UNITED STATES PATENT AND TRADEMARK OFFICE

APPLICATION NO.	FILING DATE	FIRST NAMED INVENTOR	ATTORNEY DOCKET NO.	CONFIRMATION NO.
10/783,498	02/20/2004	Li-Shyue Lai	TSM03-0199	7579

Office Action Summary

DETAILED ACTION

FIG. 10

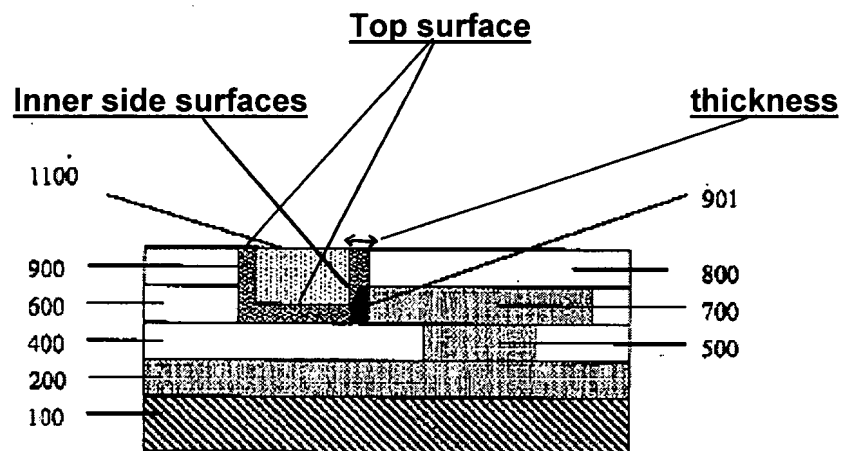
Regarding claims 1, 29 and 30, Lung (Fig. 10) discloses a phase change memory cell fabricated on a semiconductor substrate 100 comprising: an insulating dielectric layer 400; a thin conductive film 700 having a first film thickness on the dielectric layer 400, the plane of the film 700 being generally parallel to the plane of the dielectric layer 400; a layer of a phase change material 900 (par. [0049]) having a

second film thickness supported by the dielectric layer 400, wherein the phase change material 900 and the thin conductive film 700 are not relatively superjacent, the phase change material 900 has a substantially planar top surface (see Fig. 10 below for clarification) and has a substantially uniform thickness (par. [0047], last 3 lines); an electrically resistive interface 901 between the thin conductive film 700 and the phase change material layer 900, the interface 901 being defined by an area of engagement between the film 700 and the layer 900 that is generally normal to the plane of the dielectric layer 400; and an electrode 1100 superjacent to the phase change material layer 900, wherein the portion of the electrode 1100 superjacent the phase change material layer 900 is also in contact with the phase change material layer 900 (claim 1), and wherein the electrode 1100 extending away from a substantially planar top surface of the phase change material layer 900 in a direction generally perpendicular to a major surface of the substrate 100, the electrode 1100 not being coterminous with the phase change material layer 900 (claim 29).

Lung does not disclose that the thickness of the thin conductive film 700 is less than the thickness of the phase change material 900 at the interface.

However, Lung further teaches that the dimensions of the sidewalls for the thin conductive film 700 may be constructed "very small" and of a uniform thickness, the thin sidewalls can allow for low current and high density memory cells to be formed (par. [0053]). Accordingly, it would have been obvious to form the thin conductive film 700 having a thickness being "very small" and less than the thickness of the phase change material 900 at the interface in order to provide a memory cell having low current and high density.

Regarding claims 2-3, 5, 33 and 35, Lung's Fig. 10 further discloses that the width of the conductive film 700 generally parallel to the plane of the dielectric layer 400 and the height of the conductive film 700 generally normal to the plane of the dielectric layer 400 determine the area of engagement (claims 2-3 and 35). Therefore, the current path from the interface into the phase change material layer 900 inherently lies in a direction substantially parallel to the plane of the substrate, and the current path from the phase change material layer 900 into the contact 1100 inherently lies in a direction generally normal to the plane of the substrate (claims 5 and 33).

Regarding claims 4 and 32, because the width of the conductive film 700 is parallel to the plane of the substrate, the heat produced by current through the interface 901 would also flow from the interface 901 into the phase change material layer 900 in a direction parallel to the plane of the substrate.

Regarding claims 6 and 31, Lung's Fig. 10 further discloses that the phase change material layer 900 and the thin conductive film 700 are not relatively superjacent or subjacent, and the conductive material 700 comprises a high band gap and high thermal conductivity material of titanium nitride (par. [0051], last 3 lines).

Regarding claim 36, Lung (Fig. 10) discloses a memory cell, comprising: a layer of phase change material 900; and an elongated thin conductive film 700 having one end engaging a side of the layer 900 to define an interface 901 having a width and a height, wherein the thin conductive film and the layer of the phase change material engage at an interface and wherein the thin conductive film 700 has a thickness at the interface that is thinner than the phase change material 900 at the interface; an electrode 1100 immediately adjacent the phase change material layer 900 and extending away from the bottom surface of the phase change material 900 in a plane substantially perpendicular to a longitudinal axis of the elongated thin conductive film 700. It is also noted that the process limitations recited in a "product by process" claim (determined non-photolithographically, by thin film deposition parameters)) would not

Regarding claims 37-38, because the width of the conductive film 700 generally parallel to the plane of the substrate and the height of the contact 1100 generally normal to the film 700, the current flows from the interface into the phase change material layer 900 generally parallel to the film 700 and the current flows out of the layer 900 into the contact 1100 generally normal to the film 700.
